Response to Mediation Questions

Proposed Shelburne Pit/Quarry

**RE: Response to Mediation Questions
Proposed Shelburne Pit/Quarry**

Figure 1: Location of the NVCA Pine 1 streamflow station.

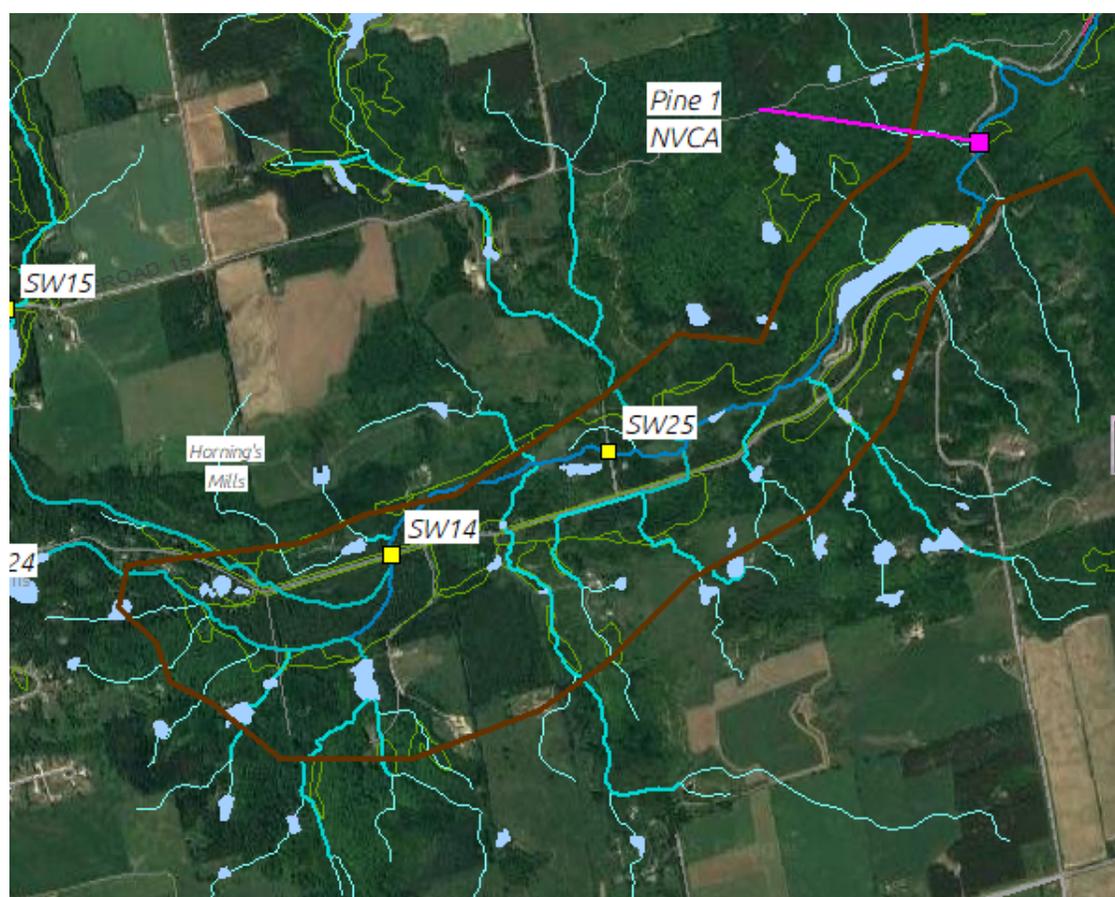
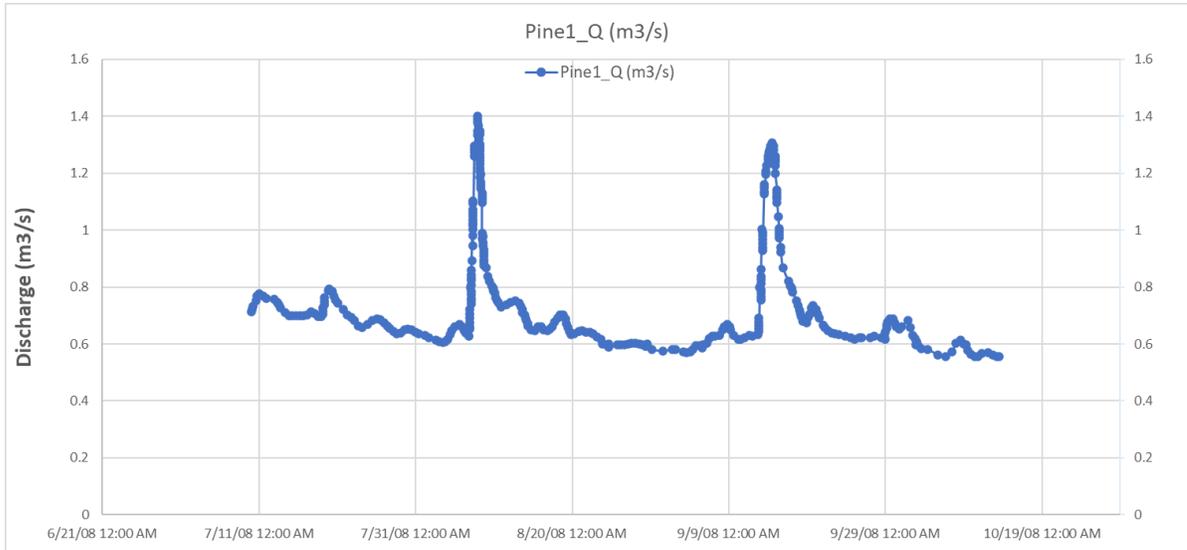
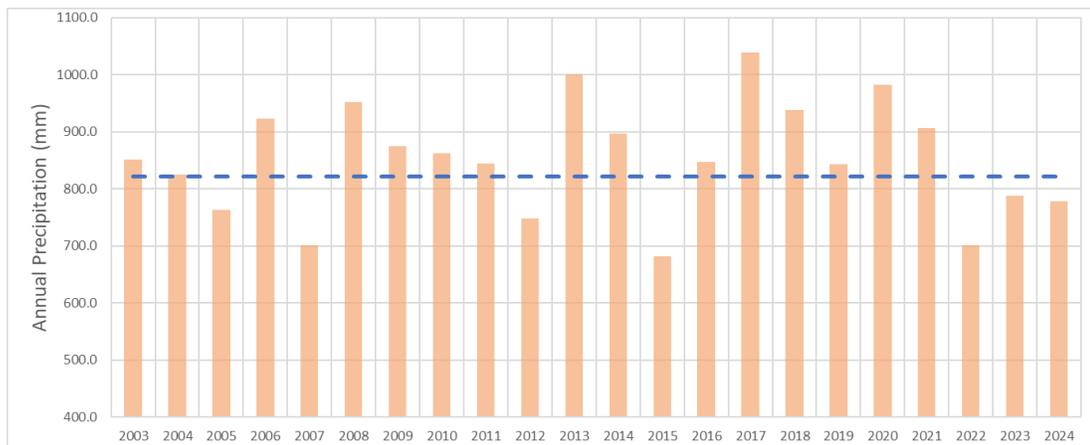
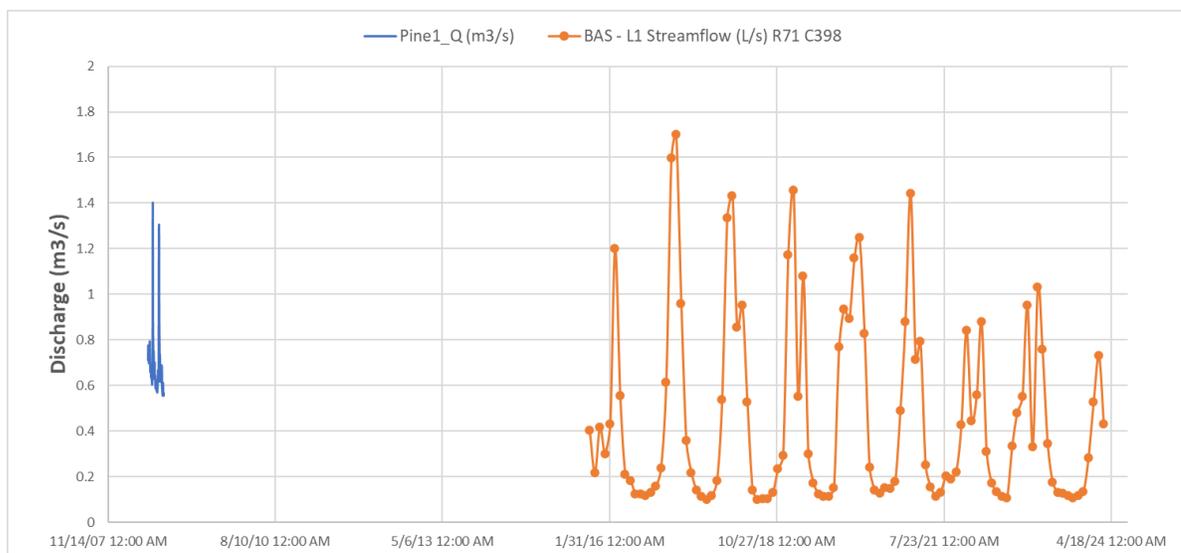
Hunter Comment 1.4 *My Dec. 10 request to Strada sought to systematically compare the Strada Model dry weather STRs [streamflows] to observed dry weather flows at Mega Quarry (Genivar), NVCA and Strada stream gauging sites.*

RESPONSE: This question was addressed in detail at the meeting held on March 6th, 2025. Additional streamflow information was provided by Hunter after the March 6th meeting for three Pine River stations that were part of the Niagara Escarpment Baseflow Study (NVCA, 2009). The stations are located between Tatham monitoring station SW25 and the long-term Water Survey of Canada (WSC) gauge at Everett. Calibration to SW25 was discussed on March 6th, and detailed calibration to the long-term WSC Everett gauge is discussed on Appendix Page D-58. The NVCA stations contain only three months of measurements collected between July 10th, 2008 to October 13th, 2008.

Figure 1 shows the location of the most relevant Pine 1 NVCA streamflow station downstream of Horning's Mills and Tatham monitoring stations SW14 and SW25. The Pine 1 station is downstream of a large power dam pond that is now referred to as the Pine River Provincial Fishing Area. The weir conditions, bathymetry, and operation of the dam are unknown but likely moderate natural streamflow response at the Pine 1 station.

Figure 2 shows the three months of NVCA streamflow data spanning the end of summer and beginning of fall of 2008. The hydrograph shows a steady baseflow of about 0.6 m³/s, with two distinct storm flow events.

Figure 3 shows the annual and mean annual precipitation in the watershed, and illustrates that 2008 was a relatively wet year.

Figure 4 compares observed streamflow at the Pine 1 NVCA station and simulated streamflow at the same location. Like the results at SW14 and SW25 discussed on March 6th, the Pine 1 simulated streamflow falls within the range of measured values reported by NVCA at this station. This demonstrates that the model simulation at Pine 1 is consistent with the limited Pine 1 observation data.

NVCA Pine River stations 2 and 3 are further down stream and nearer the long-term WSC Station at Everett. Given their proximity to the extensive calibration analysis at Everett (page D-58), they provide limited additional value for assessing the quality of the model calibration.

Figure 5: Location of STR9, STR8 and STR7

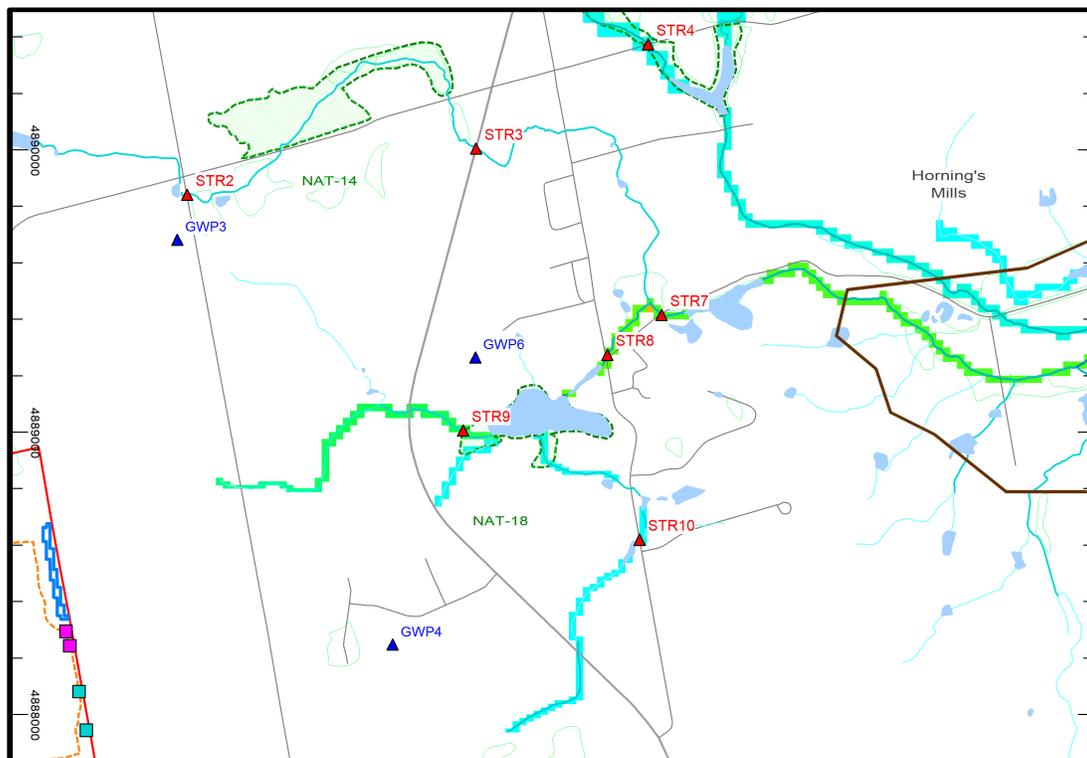
Hunter Comment 2.2 Strada's current Oct 2024 Groundwater Model (at face value) and Oct 2024 Site Plan Infiltration Design reduces groundwater and stream flows at Horning's Mills Main Street by as much as 50% for some extraction phases. This reduction has adverse implications for dilution of village effluents and for maintenance of Brook Trout Habitat. Corresponding measurable decreasing flow reductions may be anticipated as far downstream as the Pine River Provincial Fishing Area.

RESPONSE: Recent Tatham flow measurements and comments at the March 6 meeting indicate that inflows into the Horning's Mills Pond are likely greater from the south, where a newly identified MNR fish farm operation is/was located (see location STR10 in Figure 5). Further, new 2024 Tatham measured streamflows upstream of STR9 are negligible, indicating that any future drawdowns in that area, and corresponding decreases in flow at STR9, would have limited impact in terms of total inflow to the Horning's Mills pond.

To address Hunter's original comment, the Hunter quoted 50% change in flow is incorrect:

- The largest change in streamflow is not 50% as stated by Hunter, but 37%, at STR9. This station is on a small tributary upstream of Horning's Mills Pond (see Figure 5 below). The

model estimates limited flow at this location and, as noted above, recent 2024 field measurements by Tatham report negligible flow at this location.

- Table 1 notes that average flow reduction at STR8 is 21% of average flow and 10% at STR7
- NRSI has stated that these changes will have no impact on ecological function.

The impact on flows at Pine River Fishing Area can be evaluated by comparing the change in flow at STR7 (0.014 m³/s from Table 1) to average baseflow at the newly identified NVCA Pine 1 station discussed above (Figure 2). The average measured baseflow at the Pine 1 station is approximately 0.6 m³/s (Figure 2), so the average change in flow at the Pine 1 station would be 2.3%. It would be impossible to measure a 2.3% change in streamflow the field or distinguish that from natural variation. The Hunter conclusion that there would be an impact at the Fishing Area is not supported by the detailed flow analyses conducted with the Earthfx integrated groundwater/surface water model.

Figure 6: Site monitors in Layers 1 and 2

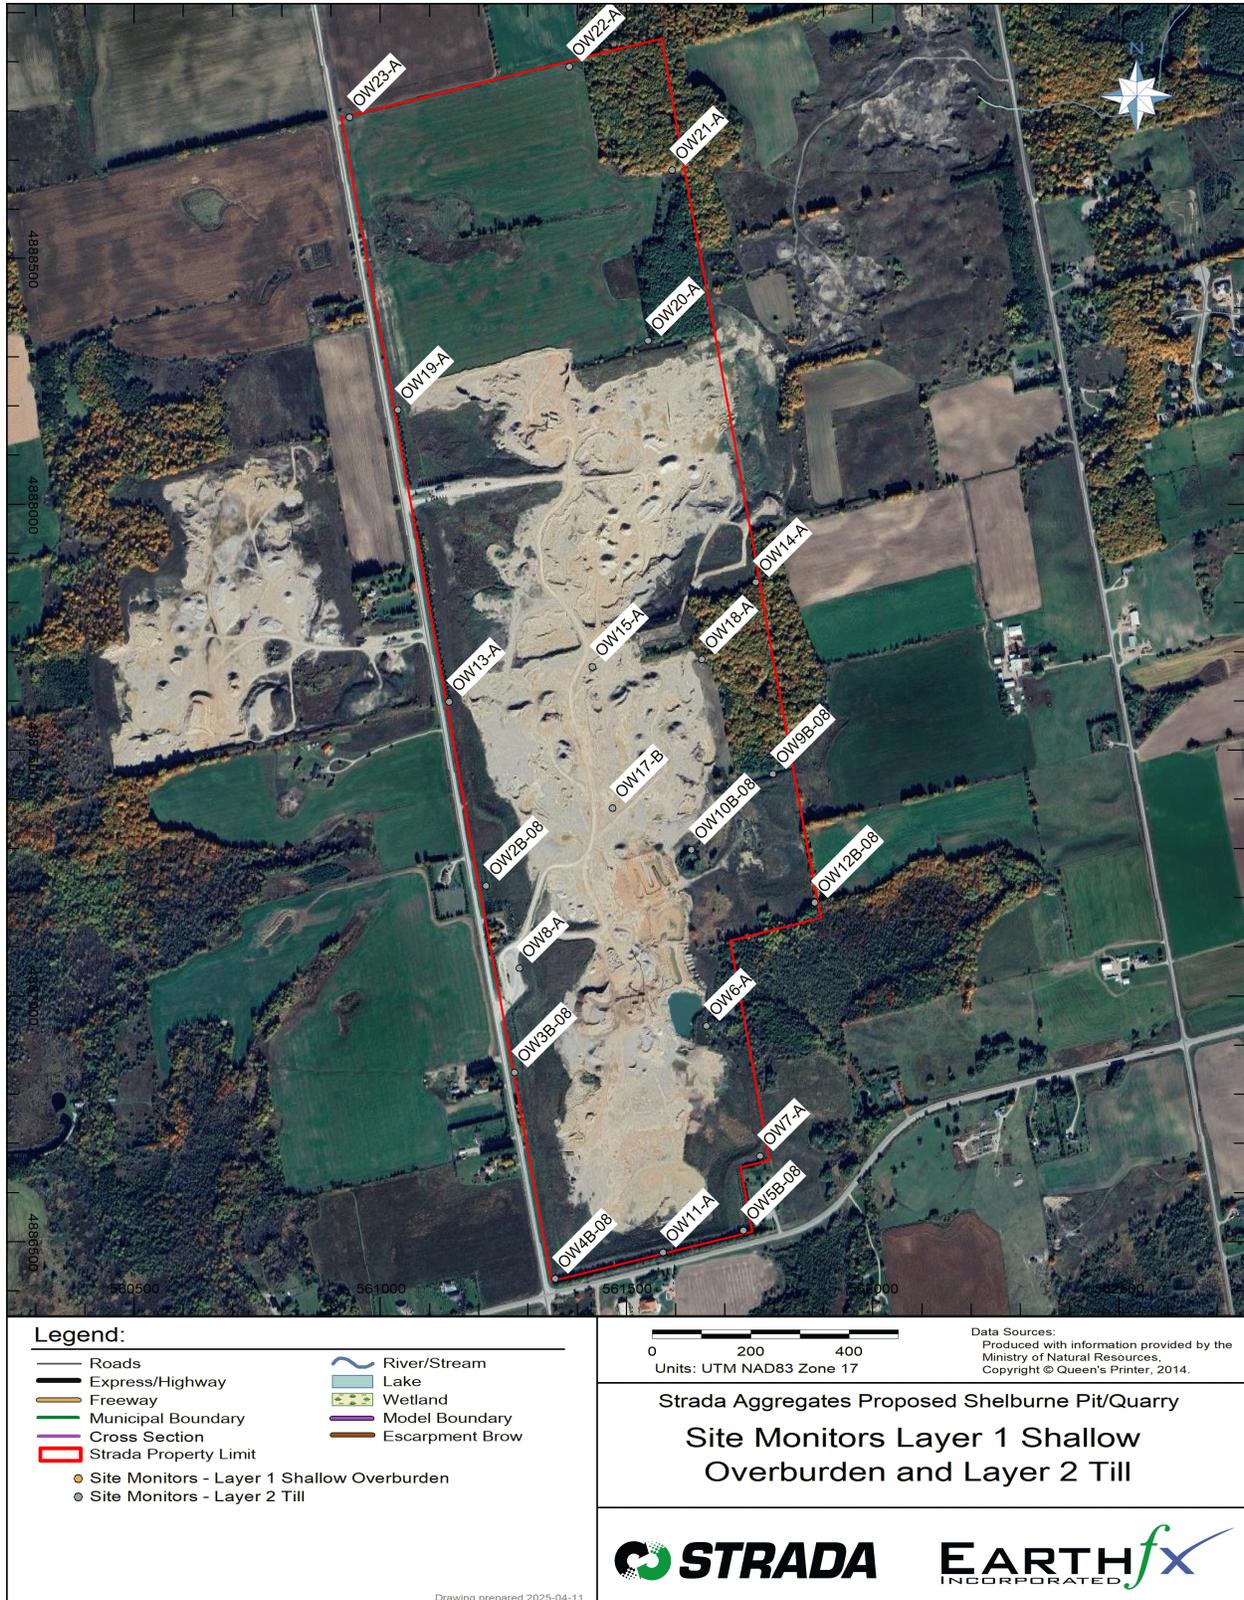
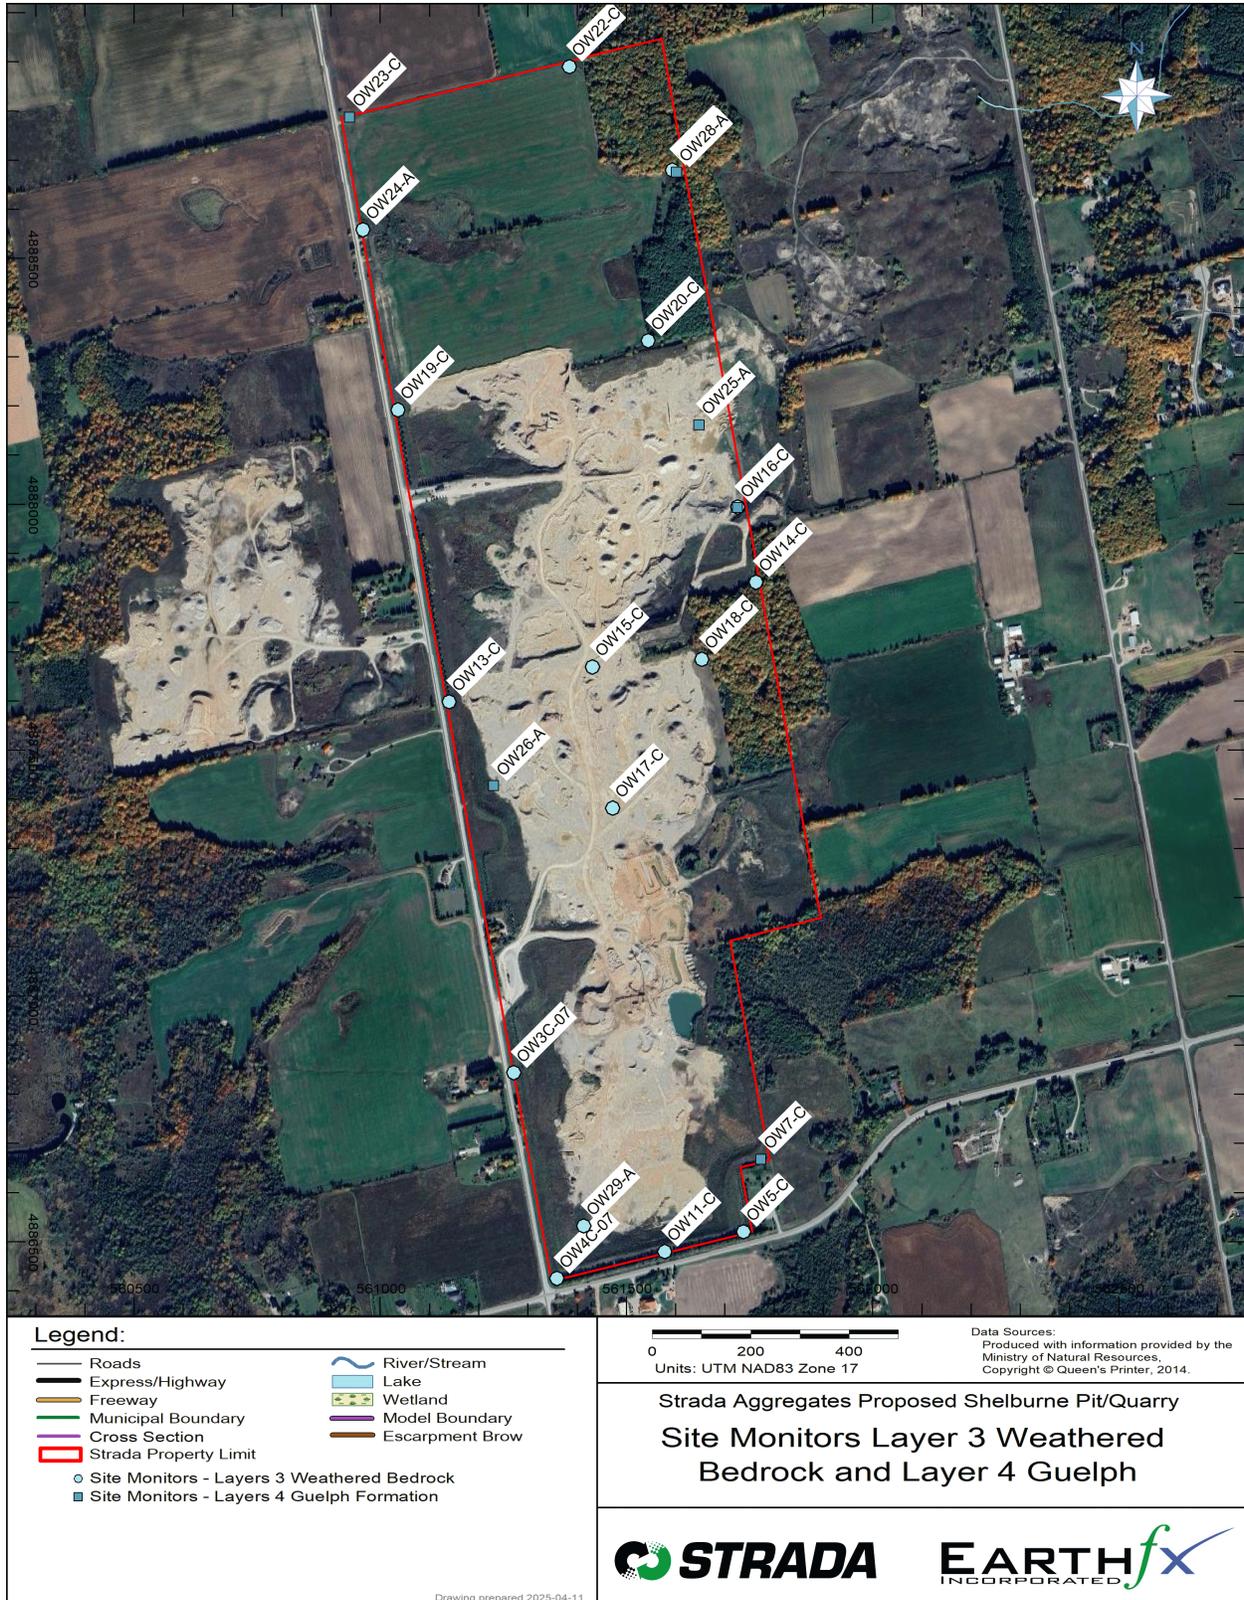
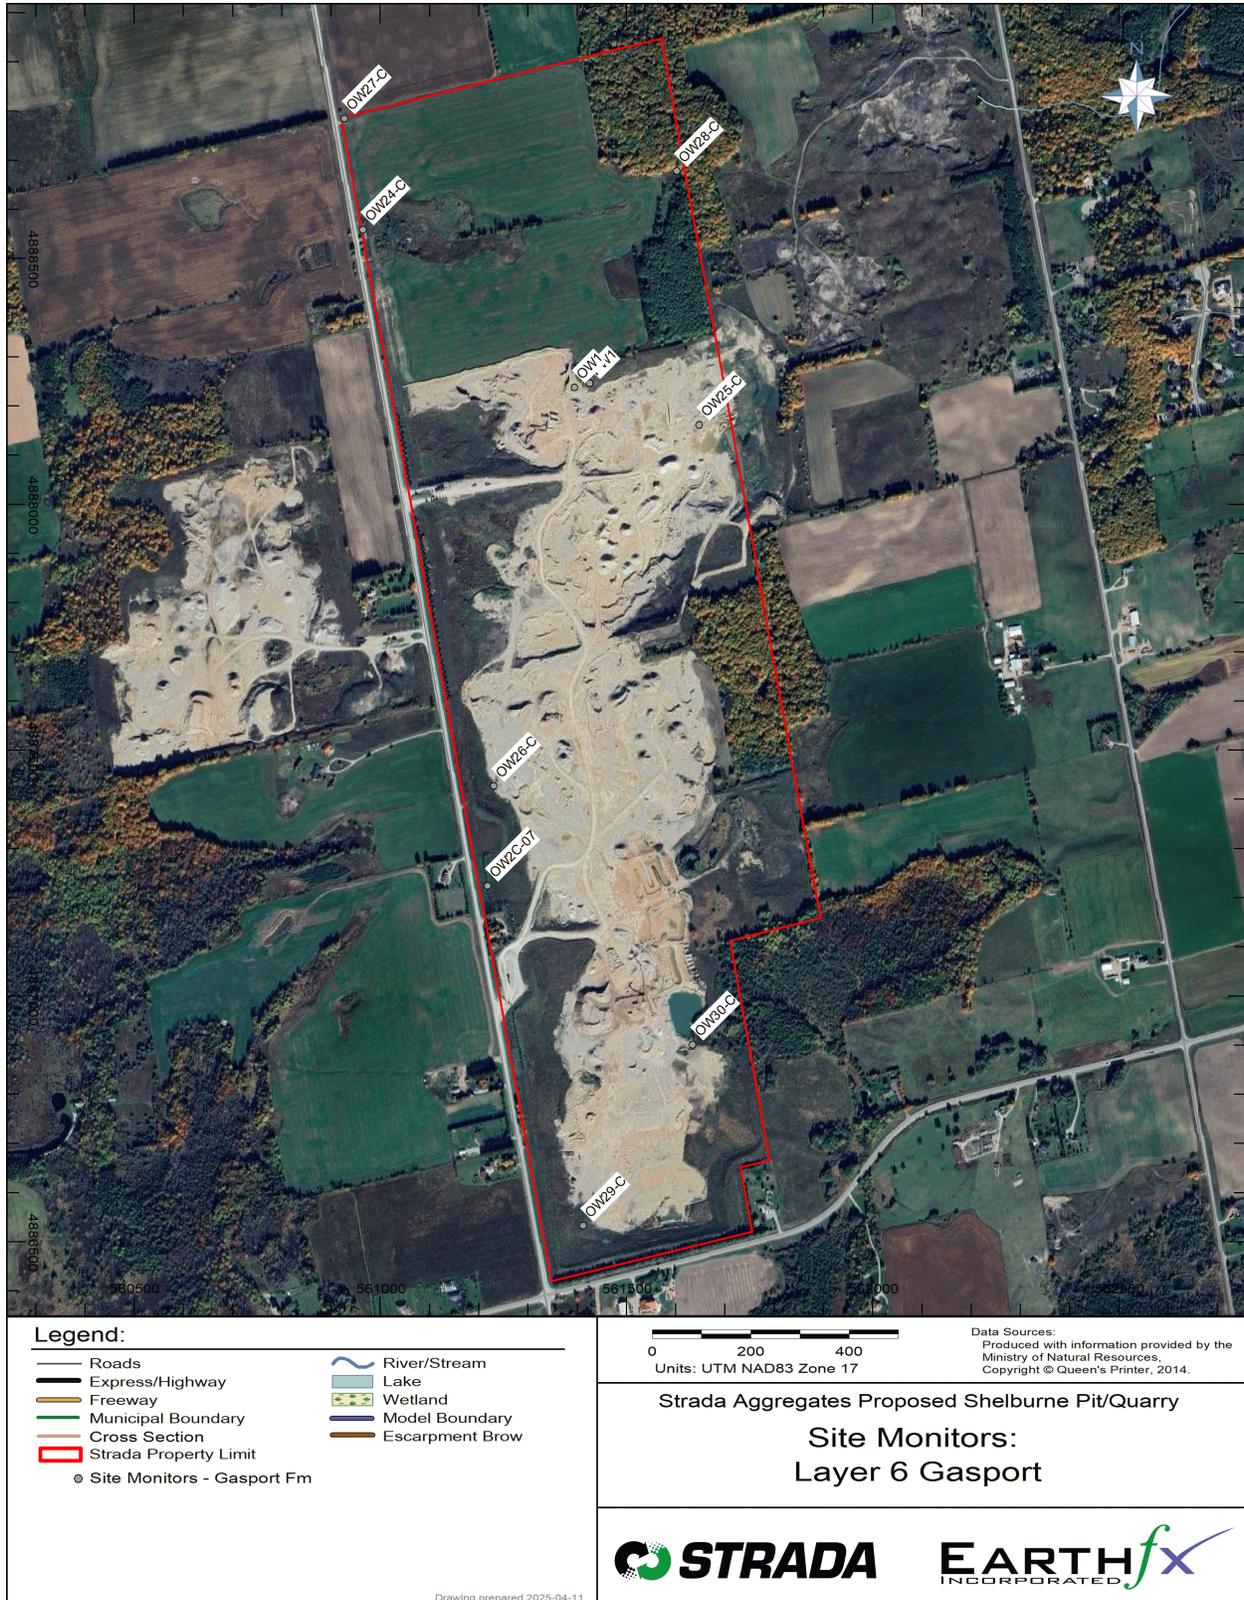
Hunter Comment 6.1 *The Site Plan groundwater monitoring network has not been rationalized to long term efficient Quarry needs. Many monitors are located in areas not protected from future quarry activities including a number of deep recently constructed expensive multi-level monitors. There are a number of redundant legacy pit monitors which may be eliminated.*

RESPONSE: The current network was approved for monitoring gravel extraction operations. It also provides significant insight into long-term site conditions. This network has been expanded to include deeper formation monitoring around the perimeter of the site, as well as off-site private well monitoring. Further, the Wellness program for monitoring conditions at private wells in the surrounding area is being implemented (for well locations, See Strada Level 2 report Figure A.6).

The expanded monitoring network, including the hydrostratigraphic layers and unit names, is listed in Table 2. (Note that Table 2, below, is the same as Table A1 in the Strada Level 2 application with the addition of addition of the layer numbers.) All of the hydrostratigraphic aquifer units are monitored, except for Layer 5, the Ancaster/Niagara Falls aquitard, which would not provide any useful hydrologic response.

Figure 6, Figure 7 and Figure 8 illustrate that the monitoring network spatially covers the entire site for each aquifer layer. While there remain a few active monitors in the central portion of the current pit, the majority of the monitors in all layers are located in the peripheral area outside of the proposed extraction area and will provide long term information.

The monitoring program will be reviewed and optimized with the MECP as part of the Permit to Take Water application and further refined with MNR as part of the development of an Adaptive Management Plan. It is expected that monitors in the centre of the site will be replaced as deeper extraction progresses, however those monitors continue to provide useful data at this time and should not be rationalized (i.e., made more efficient by removing monitors).
